Oyster Point Marina West Basin Access Improvements (Contract 2024-04)

ADDENDUM NO. 1 RESPONSE TO QUESTIONS

May 16, 2024

This ADDENDUM provides responses from the District to questions about the Invitation For Bids for Contract 2024-04, submitted by a prospective bidder.

DATE	04-10-2024
SHEET	5 OF 25
C-003

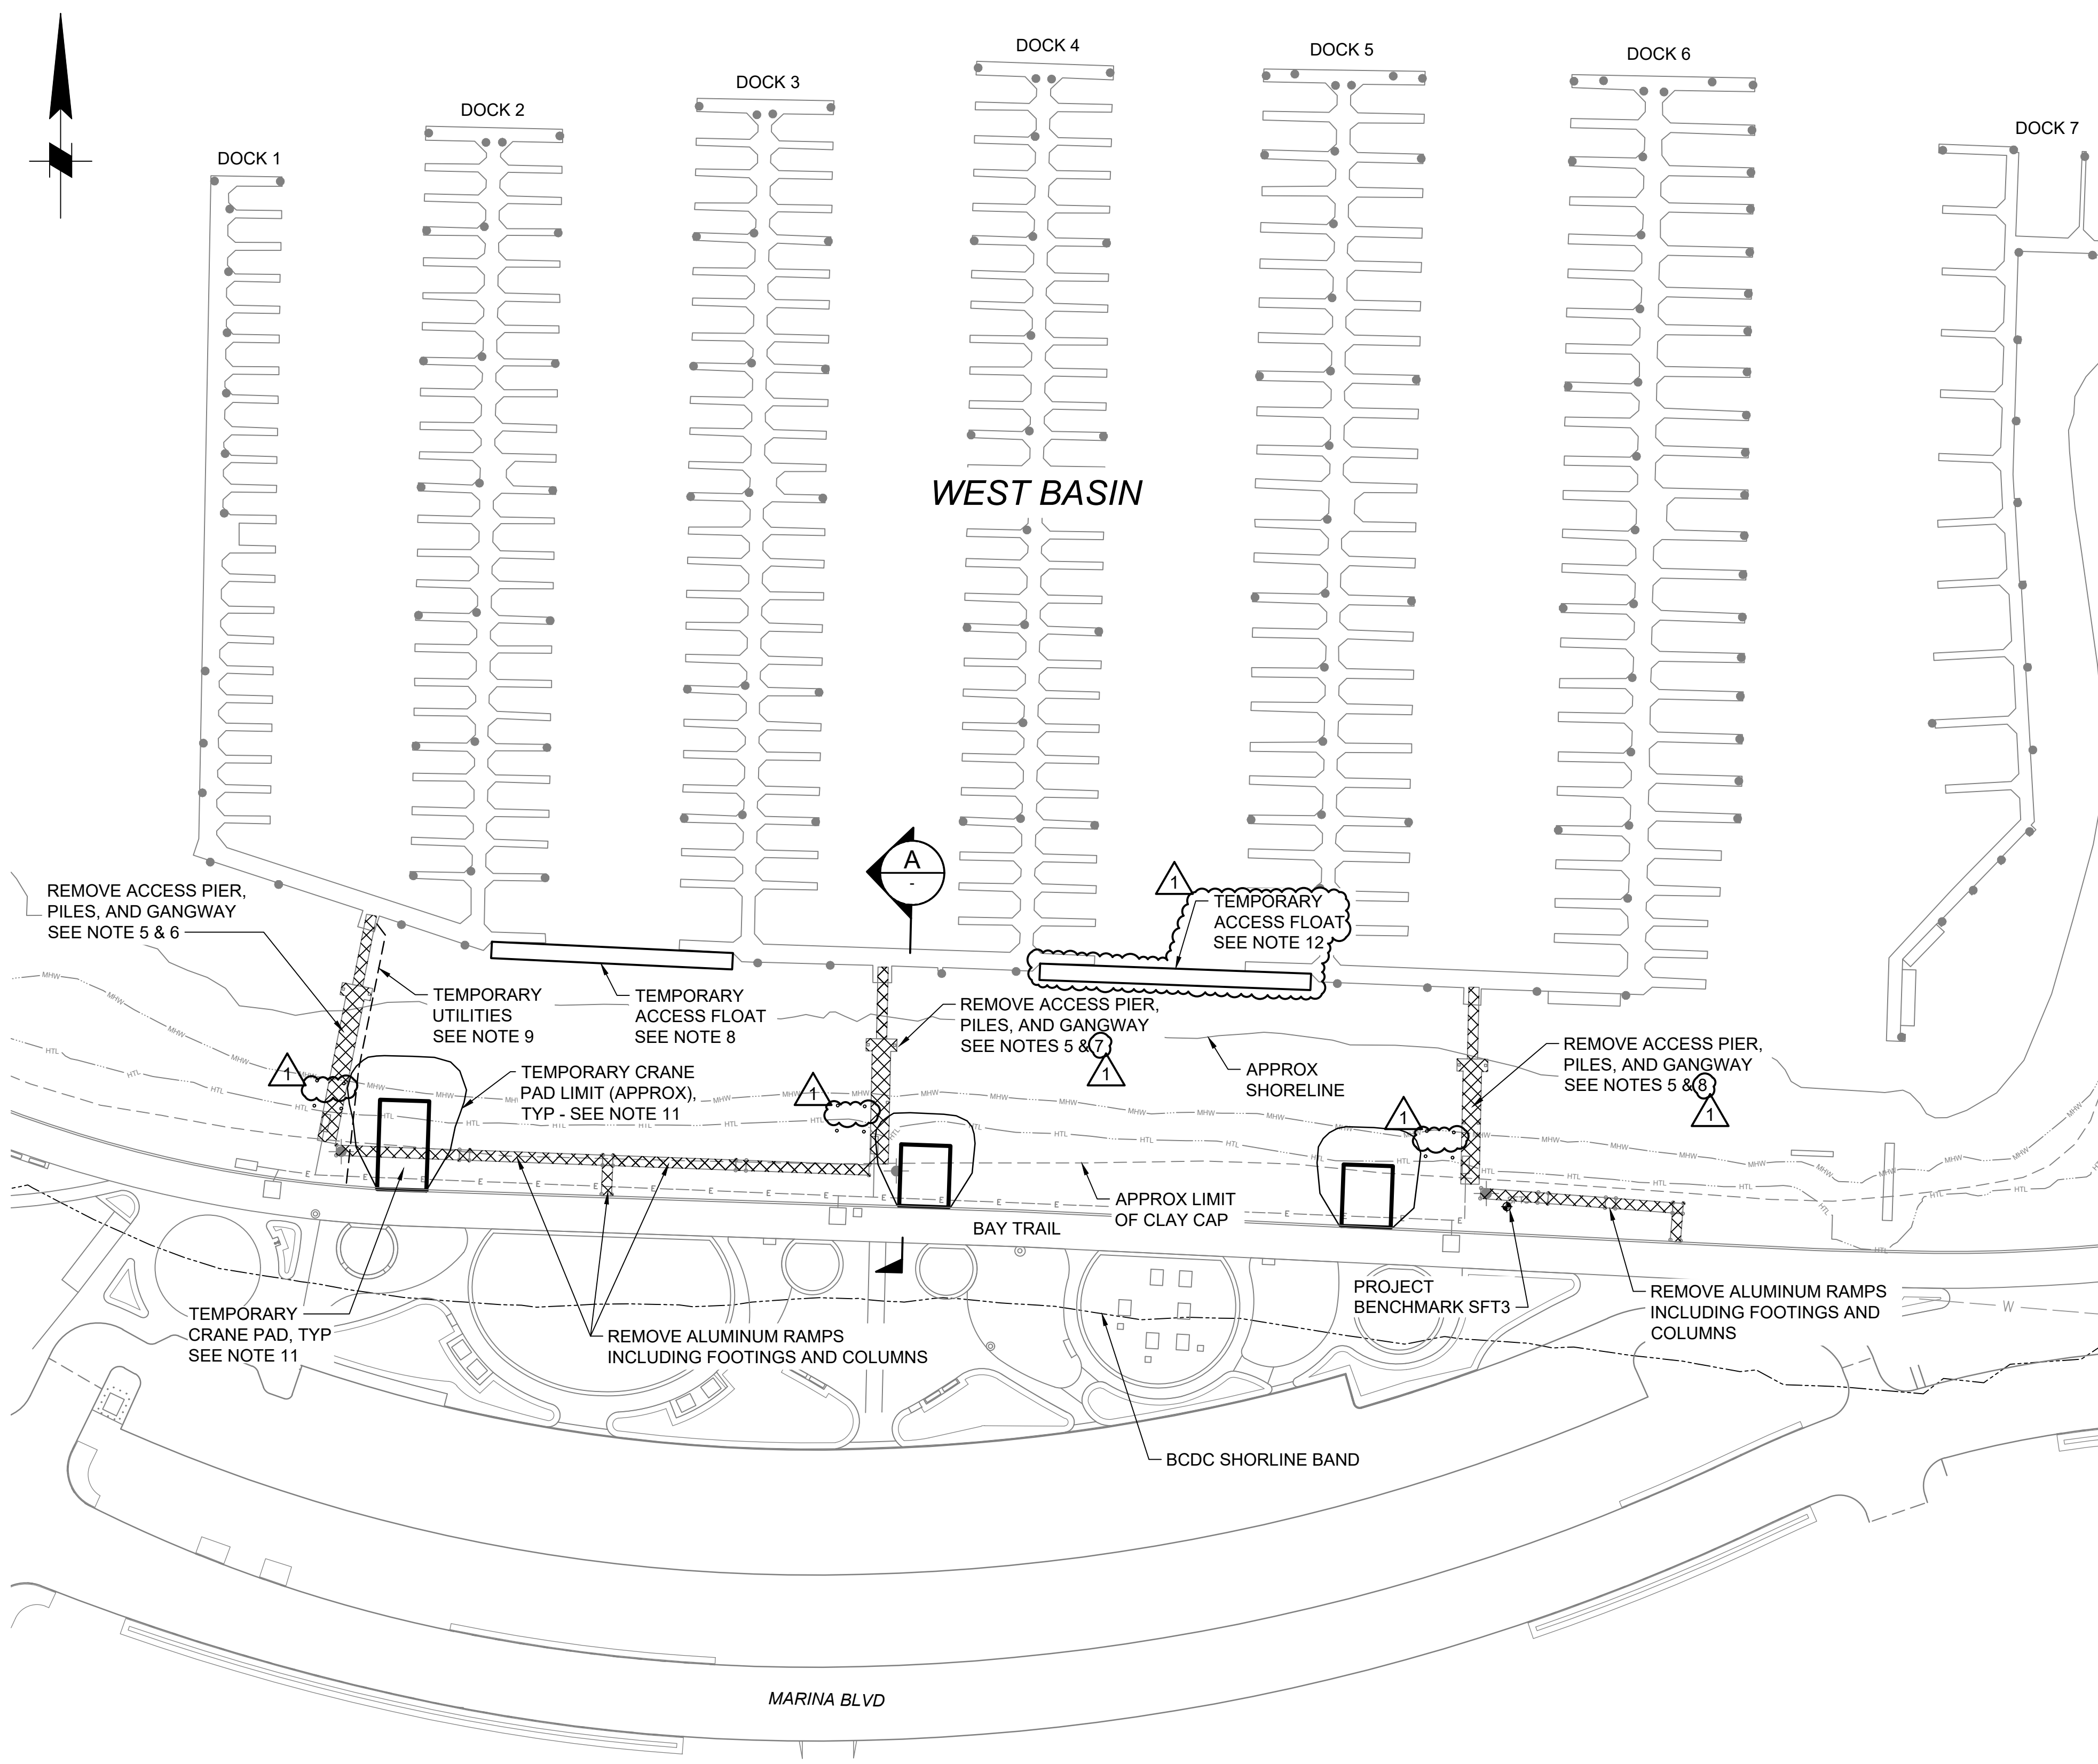
Question 13: Demolition (sheet C-003, note 5): Confirm type and size of piles to be demolished at docks 1/2, 3/4 and 5/6.

Drawing sheet C-003 "Demolition & Temporary Facilities Plan":

1. Plan View:
 - a. Add temporary access float between docks 4 and 5, and related note 12.
 - b. Delete proposed security gate and piles.
 - c. Revise callouts to reference correct notes.
 - d. Revise note 9.
2. Elevation View: Call out existing 12" concrete piles.

District response: For bidding purposes, assume the existing piles are 12" (nominal) square precast prestressed concrete.

DATE 04-10-2024
SHEET 6 OF 25
C-010

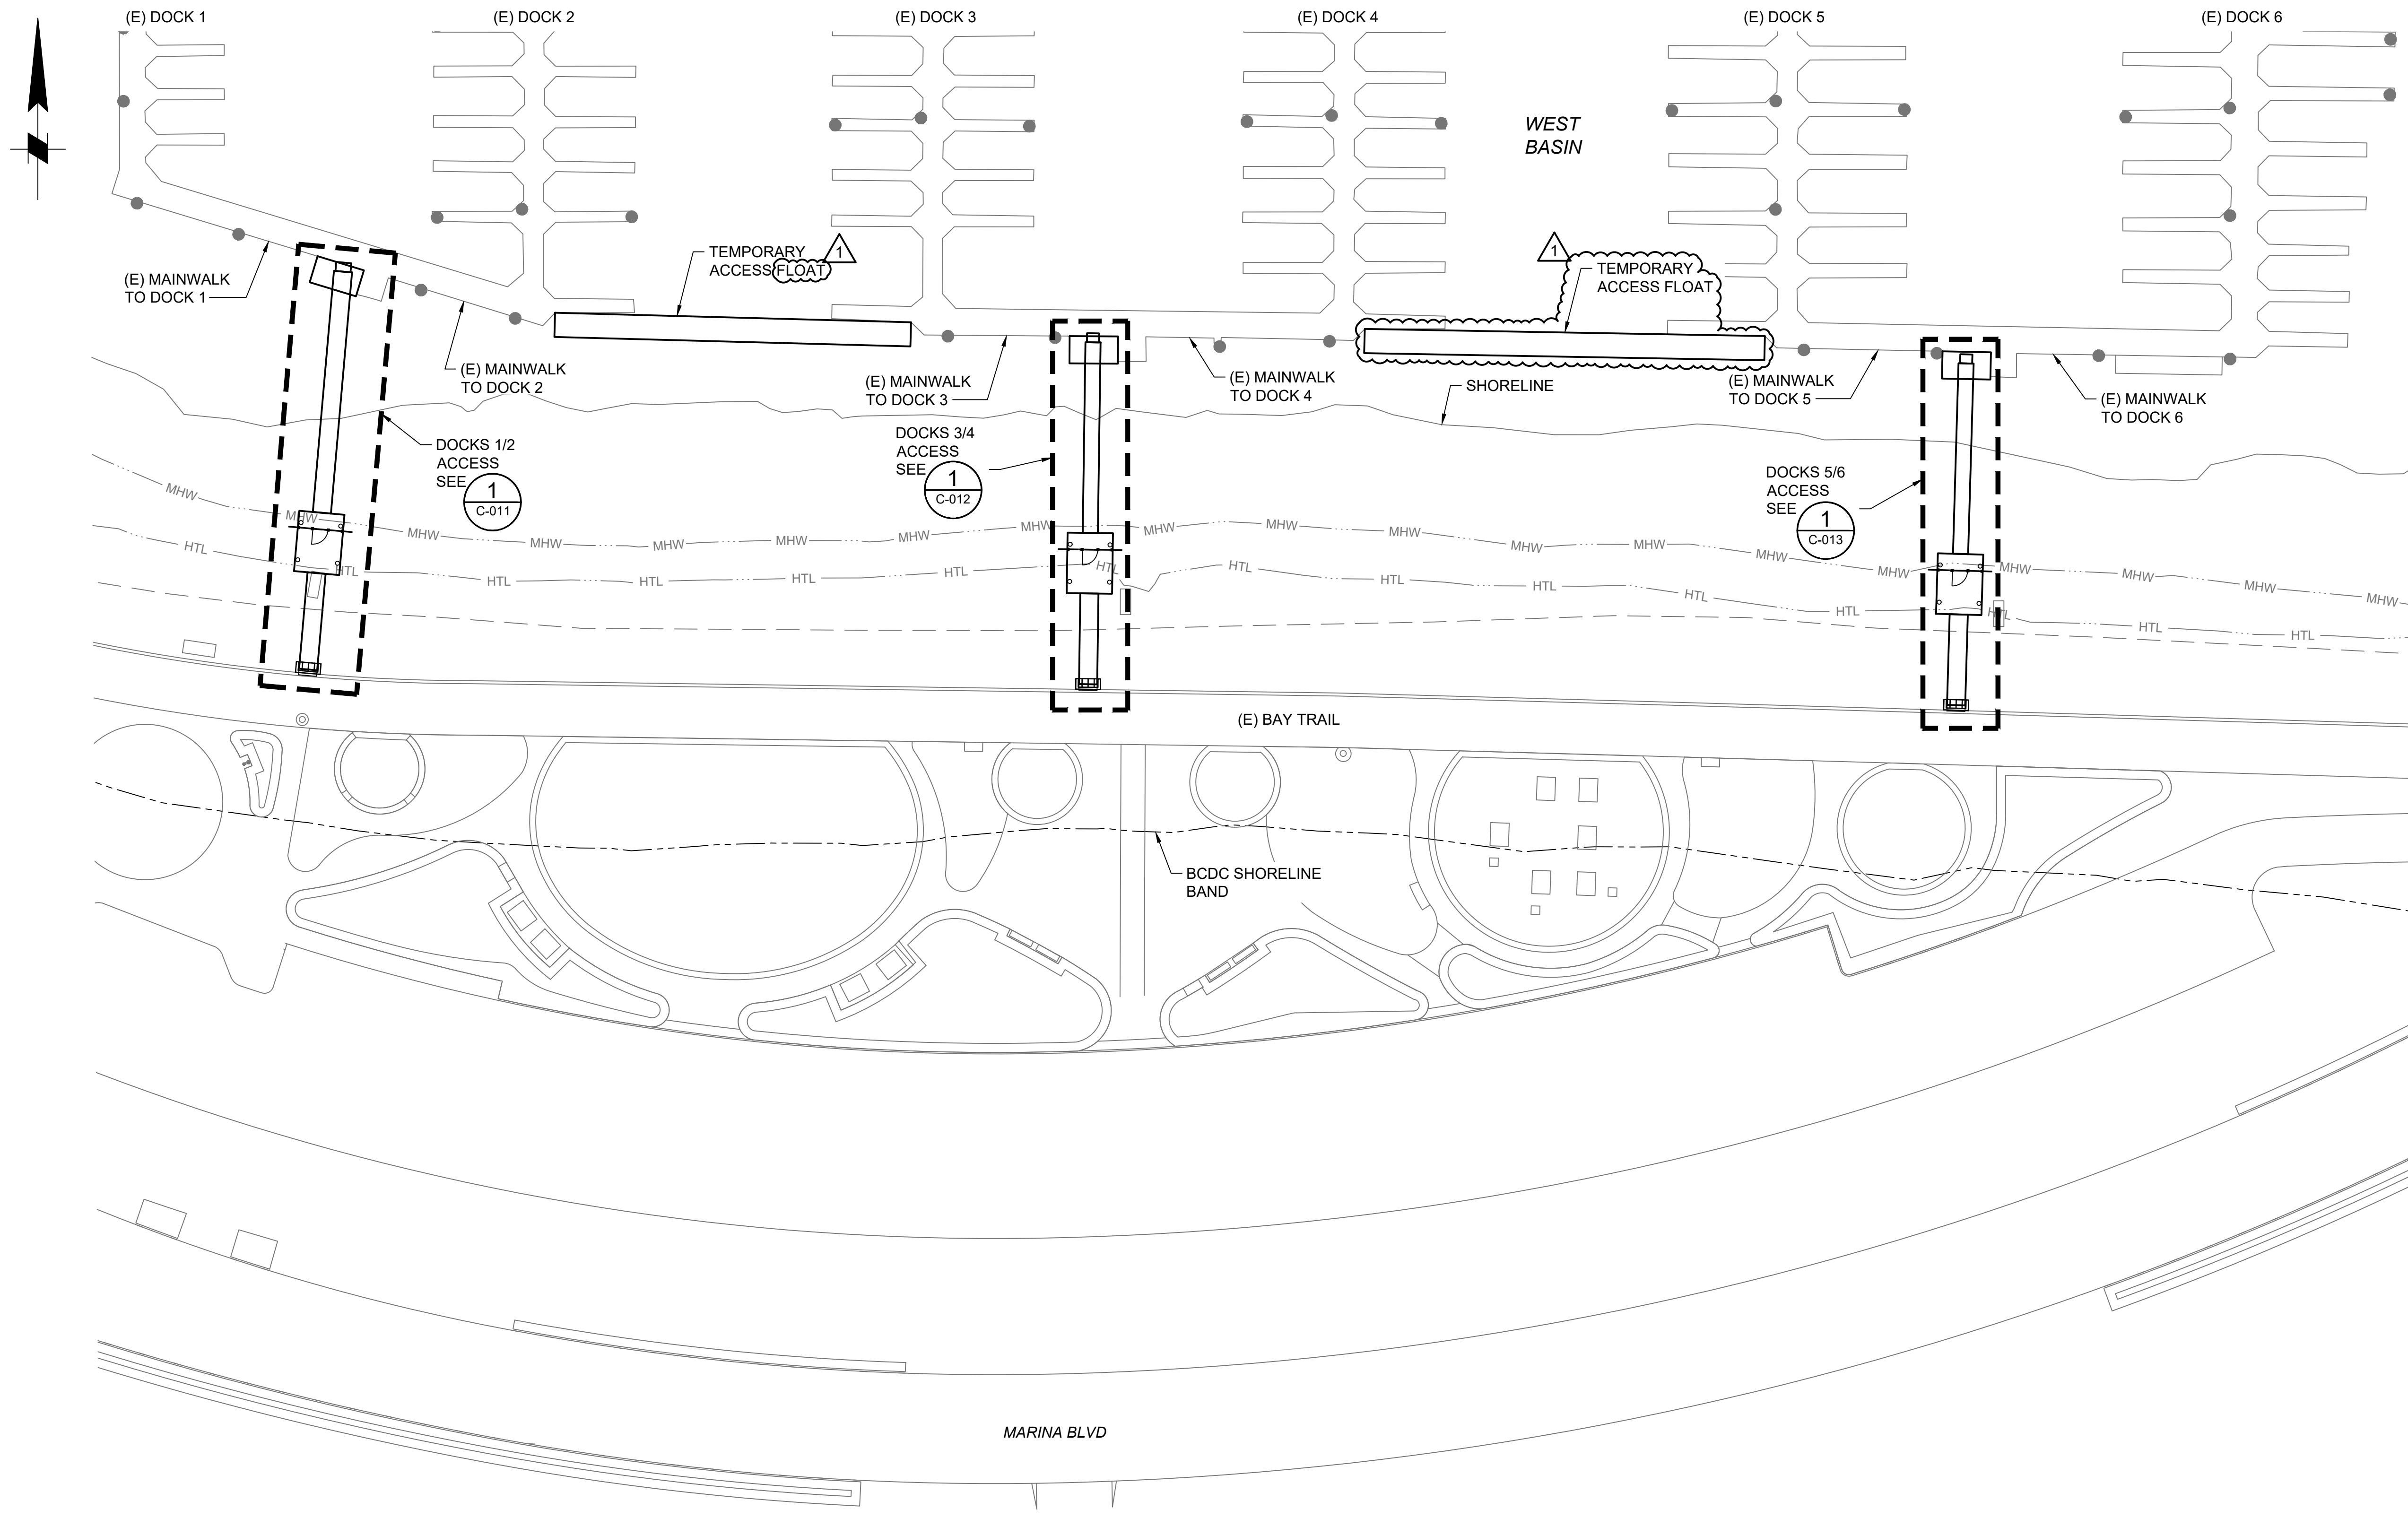
Drawing sheet C-010 "Dock Access Plan":

1. Plan View:
 - a. Add temporary access float between docks 4 and 5.
 - b. Revise "temporary access dock" to "temporary access float."
